MAHARASHTRA METRO RAIL CORPORATION LIMITED
Pune Metro Rail Project

CORRIGENDUM – II

Tender No.: P1US-01/2019 dated 14 Aug 2019

Name of Work: - Modification Of 110 KV Railway Transmission Line at Khadki by Laying 132 KV Underground Cable.

TYPICAL TRENCH CROSS SECTIONAL VIEW (FOR 2 CKT.)

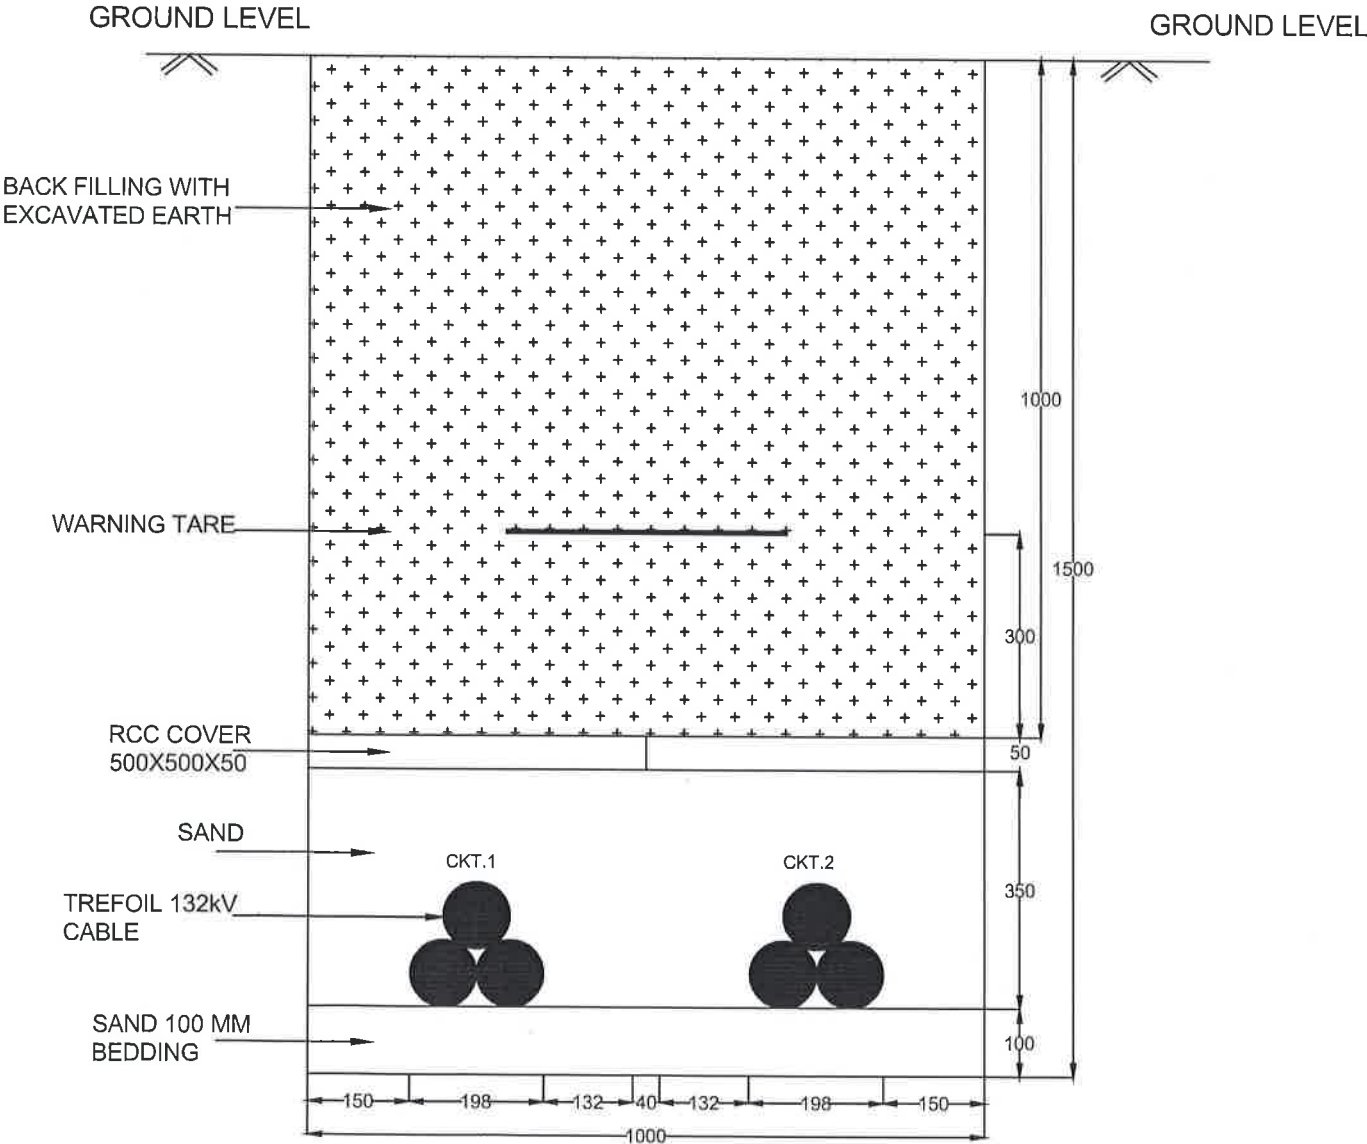
Sr.No.	Cl.No.& Section or ref.	Existing Clause / Description	Query / Request Raised by Bidder	Reply to queries raised by Bidder
1	SECTION-8, Bill Of Quantities, Sr. No. 1	Supply of 132KV, 1CX500 sq.mm.Copper, XLPE, armoured cable as per MSETCL specification	We intend to offer 132 kV 1CX500 sqmm Copper, XLPE cable with corrugated Al metallic sheath as per MSETCL specification. Please confirm.	Please refer Corrigendum I issued on dated 23-08-2019.
2	SECTION-8, Bill Of Quantities, Sr. No. 6	Supply of sheath bonding aluminium cable 1CX300 sq.mm	Short circuit rating of 40 KA for 3 Sec is specified in MSETCL specification. Cable size of 300 sqmm Aluminium is not suitable to take care of mentioned short circuit rating so we recommend 400 sqmm copper cable for sheath bonding purpose	Sheath Bonding Cable of size 300 Sq.mm Copper is to be used. Please refer Corrigendum I issued on dated 23-08-2019.
3	SECTION-7 SCOPE OF WORK & SPECIFICATION 16. Detail Scope of work is as per work description of BOQ items (Section-8) is described below.	3. Cable laying as per attached cross section complete in all respect including providing route marker throughout the length of cable route as per standard method of MSETCL 11. Excavation of cable trench in hard rock, including getting out the excavated soil and disposal of excavated soil, providing sand, back filling with excavated material, ramming as per attached cross section	Trench cross sectional drawing not found in the documents. Request to pls provide the same.	Refer Annexure I
